MECKLENBURG COUNTY HEALTH DEPARTMENT

APPLICATION FOR PERCOLATION TEST

SOIL INVESTIGATION REPORT

SITE INVESTIGATION REPORT
INDIVIDUAL SEPTIC TANK SYSTEM
WITH SUBSURFACE,
SOIL ABSORPTION,
EFFLUENT DISCHARGE

DIAGRAM OF PROPERTY

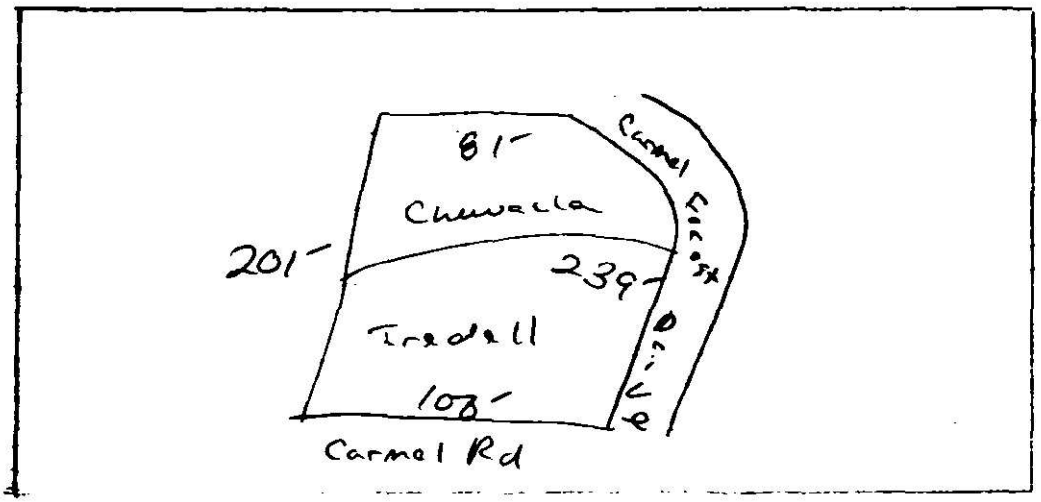
Soil Properties	Soil 1	Soil 2	Soil 3	Soil 4
1. Soil Series	Iredell		Chewacla	
2. Soil Slope	suitable 3-8%		—	
3. Soil Depth	unsuitable <30"		—	
4. Soil Texture	unsuitable silt loam and clay		—	
5. Soil Structure	unsuitable massive		—	
6. Restrictive Horizons	—		—	
7. Soil Drainage	unsuitable perched high water table		unsuitable poorly drained	
8. Soil Permeability (Percolation Rate)	unsuitable very slow >200 min./in.		unsuitable seasonal high water table <18" from surface	
9. Other			unsuitable floods	
10. Overall Rating	unsuitable		unsuitable

Remarks Recommendations Based on this investigation, the soils were found to be dominantly unsuitable for installation of a septic tank system.

See diagram on back
